**ISSUE:** Certificate of Appropriateness for alterations

**APPLICANT:** Philip Saunders

**LOCATION:** Old and Historic Alexandria District  
105 Franklin Street

## **I. APPLICANT'S PROPOSAL**

PLAT  
SHOWING HOUSE LOCATION ON  
LOT 636

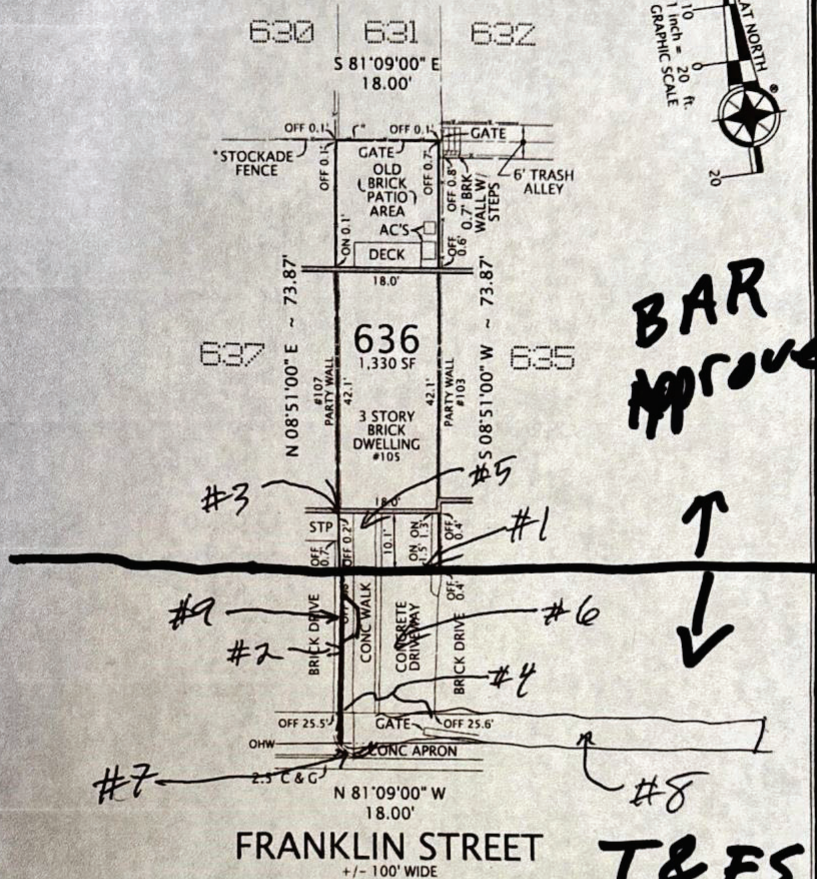
- 1) **Right-side natural area (facing the house):** The existing tree and root will be removed (the tree is leaning and unstable), a brick retaining wall will be added for aesthetic and structural purposes, and a replacement tree (Hornbeam) will be planted. **(plat #1)**
- 2) **Left-side natural area (facing the house):** This area will be narrowed by extending the new brick surface to the property line, except for a cutout area around the existing crepe myrtle tree, which will remain. **(plat #9)** This narrowing of the natural area aims to improve accessibility for walking and driving and discourage pet waste accumulation. **(plat #2)**
- 3) **Small strip between the walkway and driveway:** This strip will be removed and replaced with brick for a more cohesive appearance.

George O'Quinn at Dominion Survey has confirmed the measurements from the included plat to establish the border between 105 and 107 at the house. Either measure 0.2 feet from the edge of 107 stoop or measure 18.4 feet (width of 105 plus half width of party wall) from the right corner of 105. **(plat #3)**

A new brick landing step will be installed in front of the entry door at 105 Franklin, aligning with the design of the other four houses on the block. **(plat #5)**

Currently, the sidewalk area in front of 107 Franklin is bricked and extends into the areas in front of 105 and 109 Franklin. This project proposes to extend the brick sidewalk fully across the driveways of 101, 103, and 105 Franklin, creating a unified appearance and reinforcing the historic character of Old Town Alexandria. **(plat #8)**

Additionally, the small, rounded curb area in front of the natural area at 105 Franklin will be removed. **(plat #7)** This change will:

At the street, the border between 105 and 107 will be established by measuring 18 feet from the edge of the brick at 103. **(plat #4)** The new sidewalk brickwork will begin at this measurement and will extend to the existing concrete pad joint near the driveway opening at 101 Franklin. As part of this work, a few layers of existing brick in front of the natural area will be replaced to ensure a consistent match with the new brick, within the 18 foot wide corridor in front of 105. **(plat #4)**
